ABINGTON TOWNSHIP

**BOARD OF COMMISSIONERS
WORKING SESSION**

Presentation of the Preliminary/Final Major Land Development Plan for LD-23-04 - 640 Cedar Road (Hopewell Vet).

RE: Executive Summary for LD-23-04-640 Cedar Road (Hopewell Vet)
PARID: 30-00-06992-00-7/ TMID: 30049 004
Preliminary/Final Major Land Development Plans Review (1st Submission)

DATE OCTOBER 3, 2023
DWG. NO. A-11-B10
JOB NO. 27023
SHEET NO. 8 OF 9

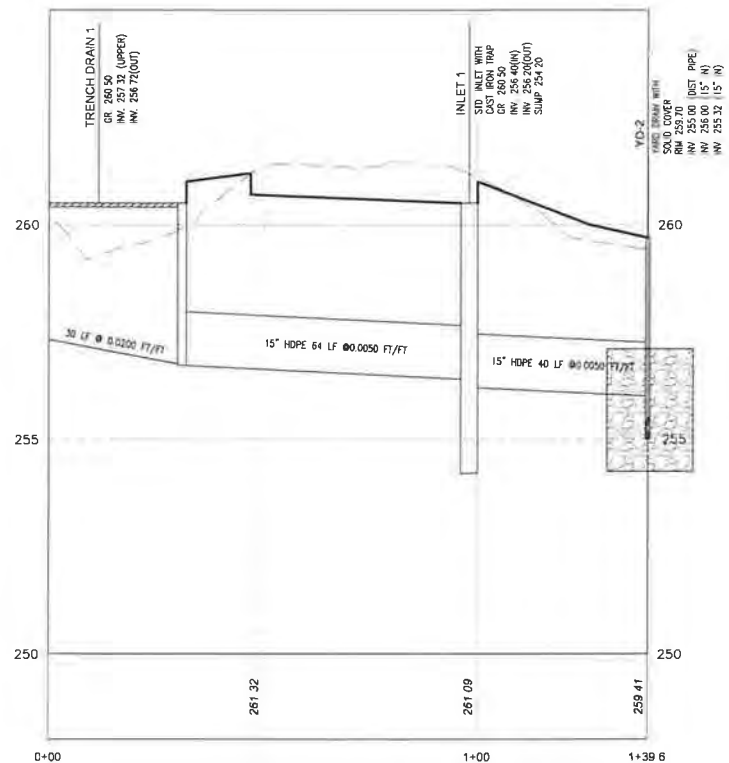
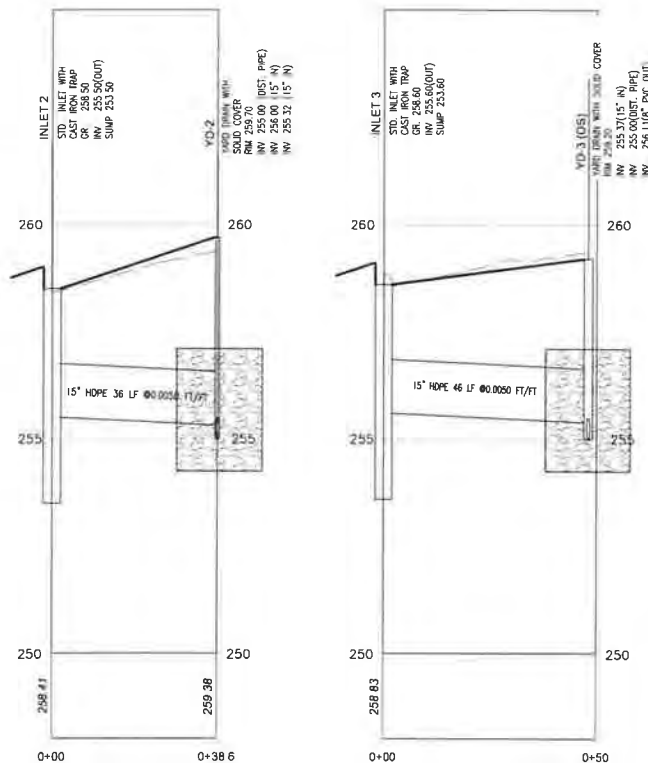
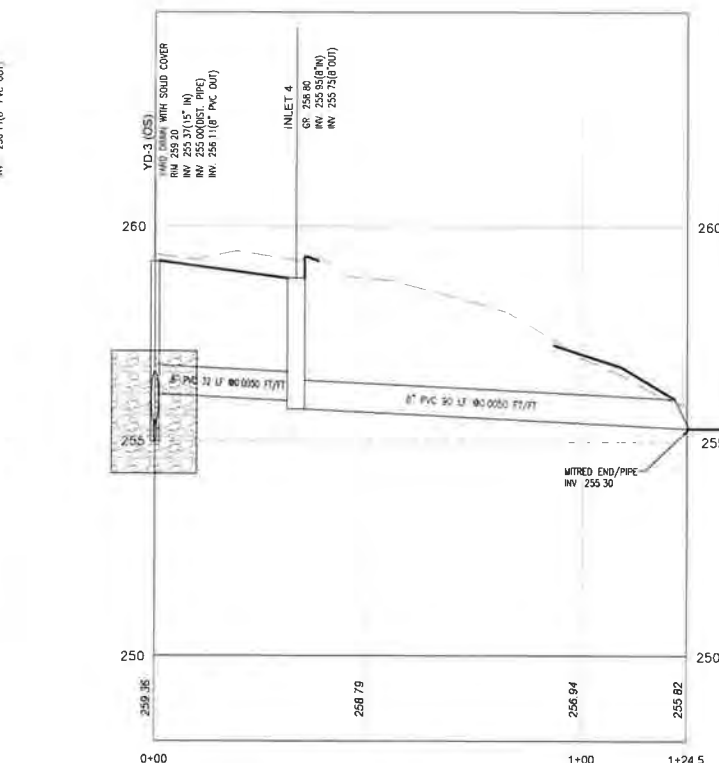
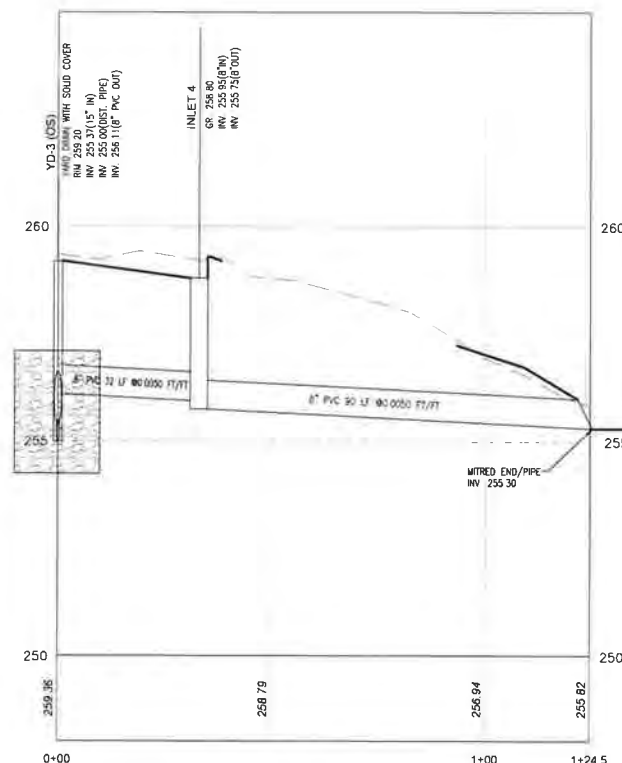
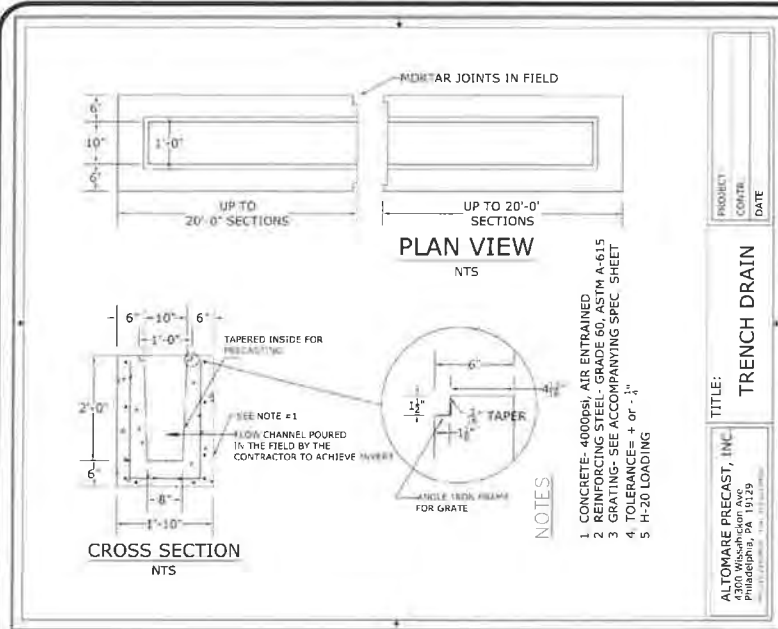
39. There are two discrepancies between the elevations provided on the Grading & Utility Plan (Sheet 5), the elevations provided on the storm profiles (Sheet 8), and the elevations provided in the PCSM Report (Pages 21-23). The discrepancies are as follows:

Project InFocus_23-14	Sheet LP-1
Date 3/23/23	
Scale As Noted

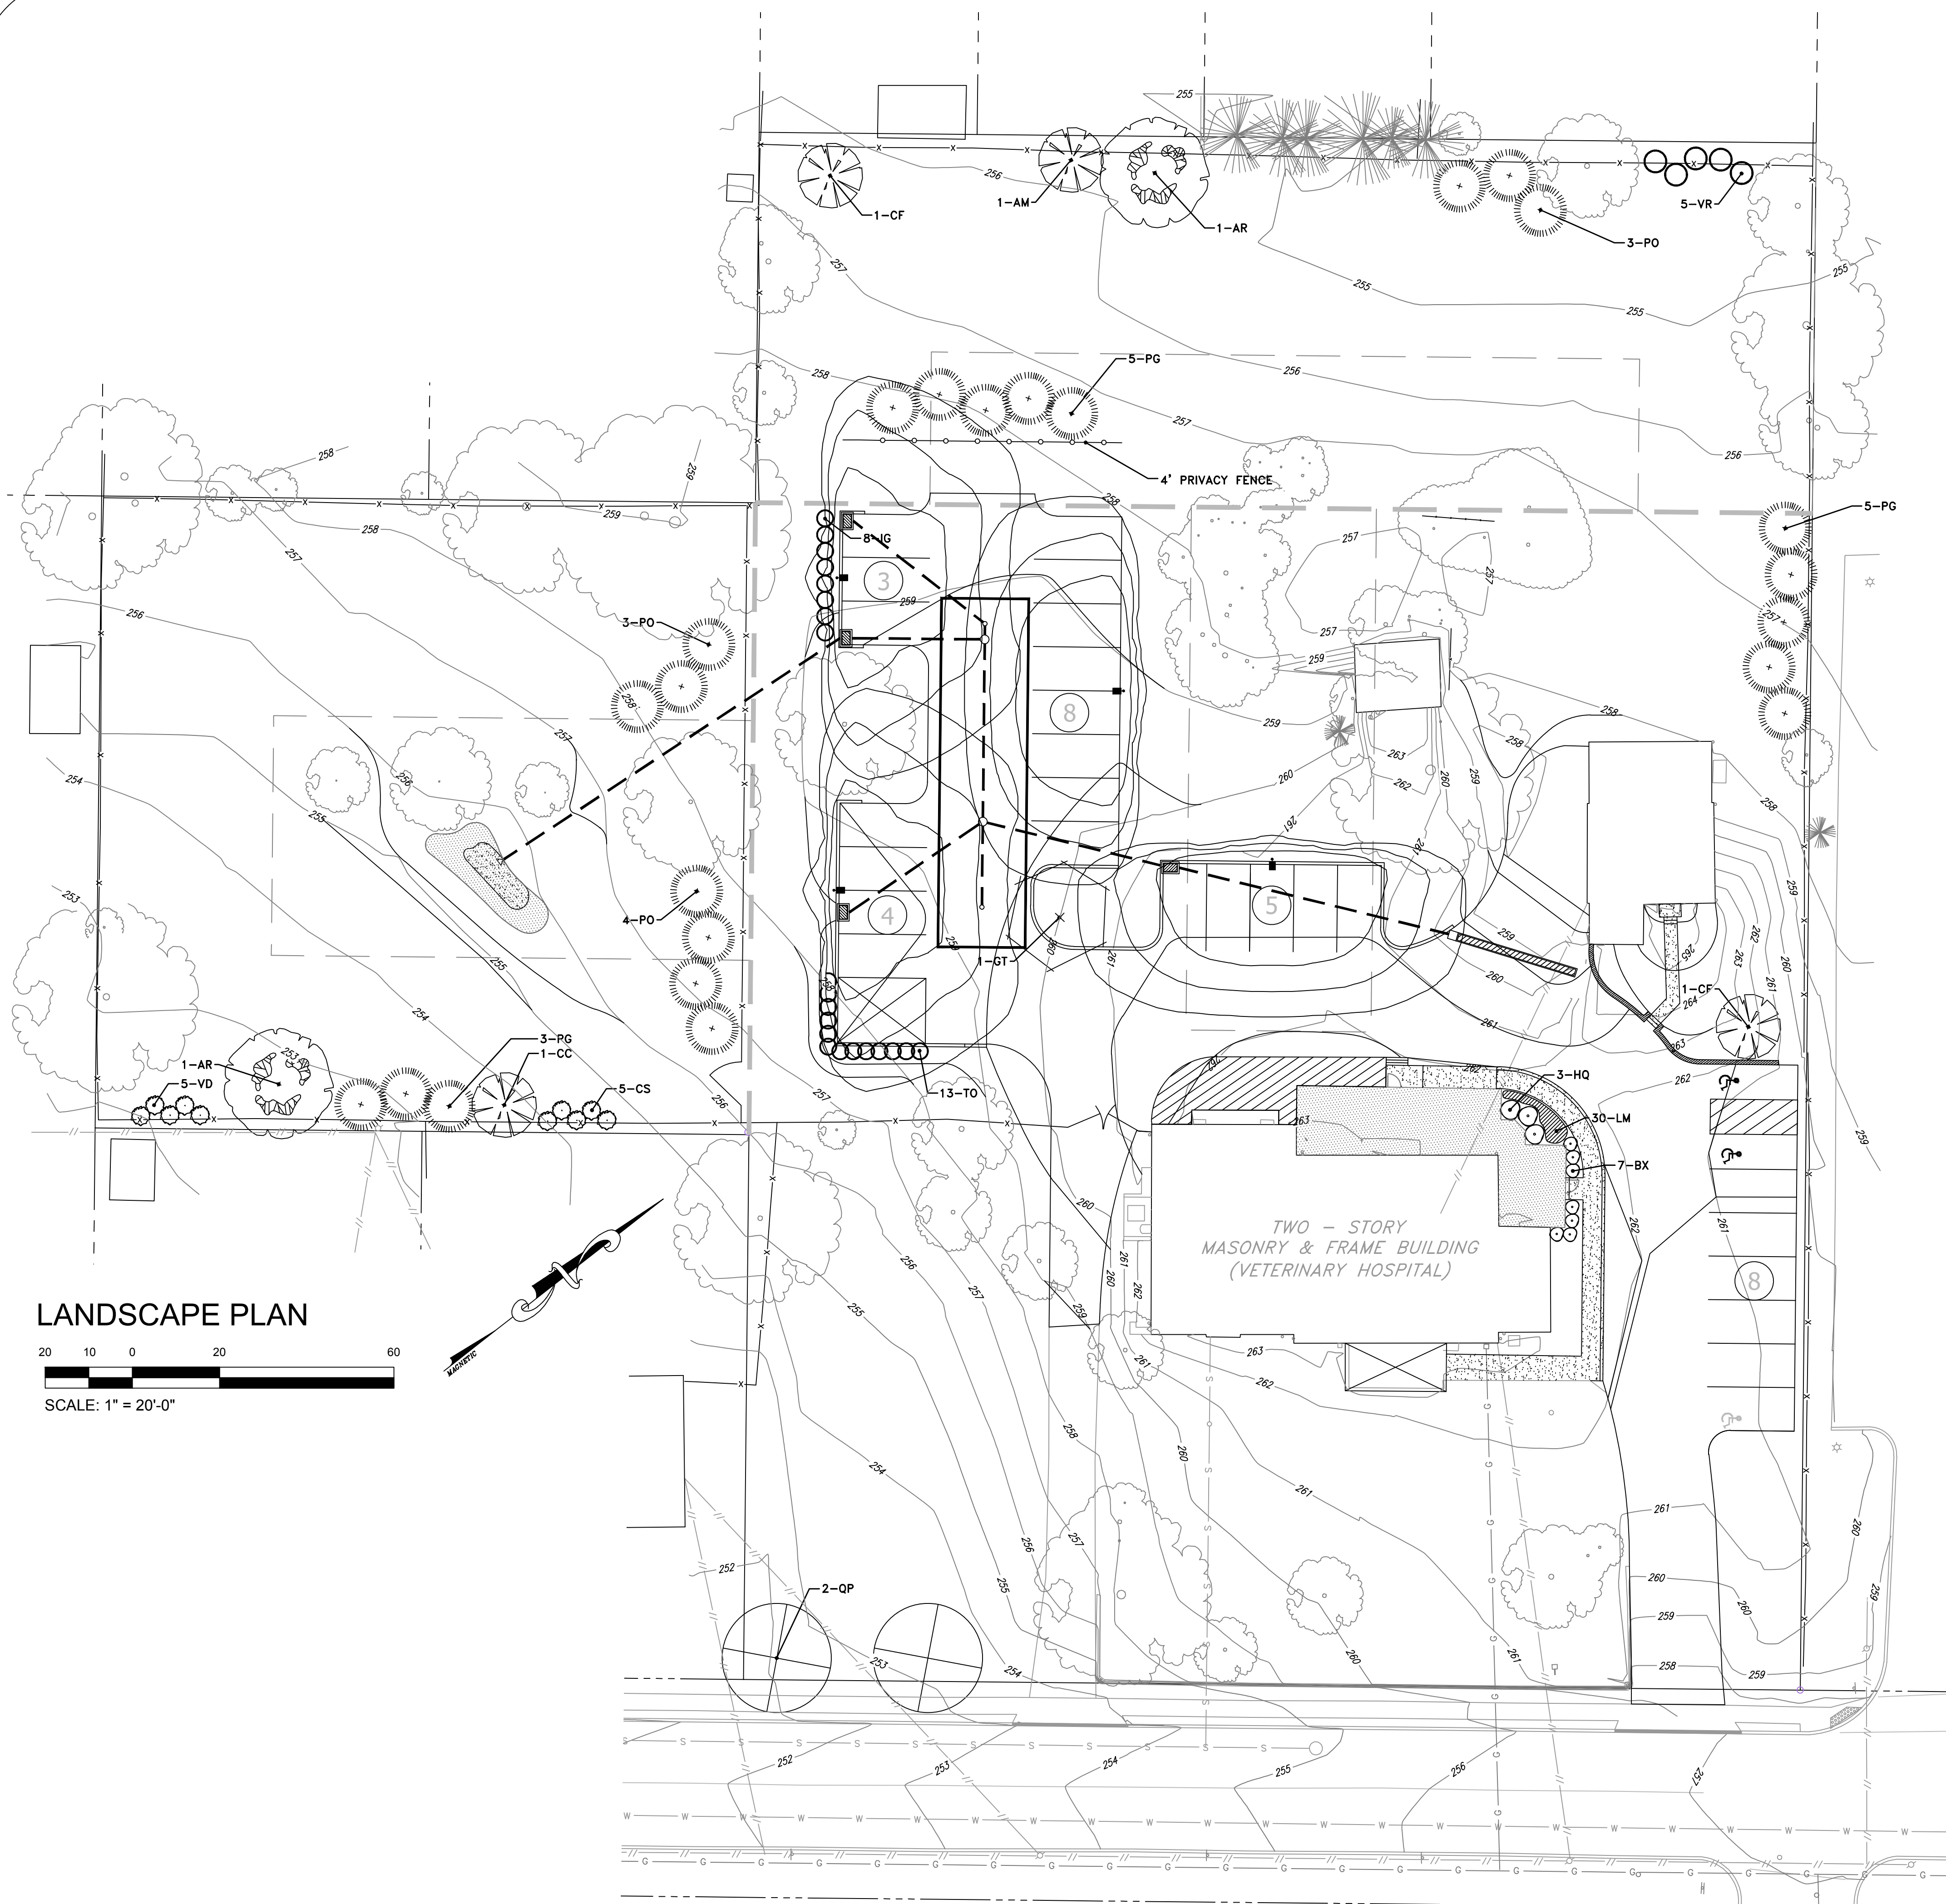
- Elevation on plans shall be based on Abington Township Sanitary Sewer datum.
- **Landscaping and Fencing:**
 - Revise the caliper size for the Acer Rubrum shade trees on the planting schedule to be a minimum of three (3) inches in caliper.

On the Landscaping Details (Sheet LP-2), the planting schedule indicated the minimum caliper size of 2.5 inches for the Acer Rubrum shade trees. Per the above Code Section, the shade trees shall be a minimum caliper of 3 inches, branching at 6 feet to 8 feet in height. The planting schedule shall be revised accordingly to reflect the minimum caliper size of 3 inches.
